MINUTES OF MEETING

Rules Change Committee

153rd Regular Meeting (No. 2019-06)

Proposed Amendments to the WESM Manual on Metering Standards and Procedures

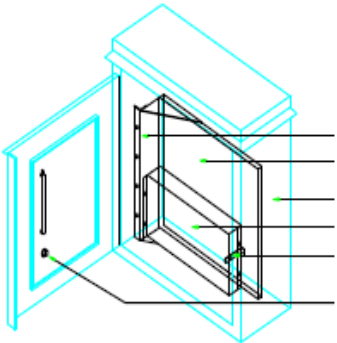
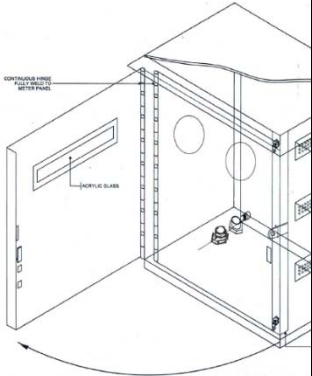
Title	Section	Provision	Proposed Amendment	Rationale	Stakeholder's Comment	NGCP's Response	RCC Discussion/ Agreements
			(see attached revised Appendix L)	of the PGC 2016 Edition	annexes may require revisions in the manual every time the PGC and PDC standards are updated. References to current specifications are proposed to be deleted to remove necessity to revise manual every time the PDC standards are updated. Proposed Revised Wording: (proposed to be deleted)	NGCP recommends to maintain its original proposal	
Appendices	Appendix N	Specifications for Current Transformers	Accuracy Class: IEC 44-1 Class 0.2/ANSI C57.13 Class 0.3 or better <u>See section 2.5.4.1</u> Burden: shall not exceed the rated burden limit of 12.5 VA for the IEC 44-1 Class 0.2/ANSI C57.13 Class 0.3 (see Table 4) <u>See section 2.5.4.1</u>	<ul style="list-style-type: none">▪ To refer section 2.5.4.1 of the proposed amendments of WESM Manuals	<u>IEMOP:</u> References to current specifications in the annexes may require revisions in the manual every time the PGC and PDC standards are updated. References to current specifications are proposed to be deleted to remove necessity to revise manual every time	NGCP to IEMOP NGCP recommends to maintain its original proposal	The RCC adopted NGCP's original proposal.
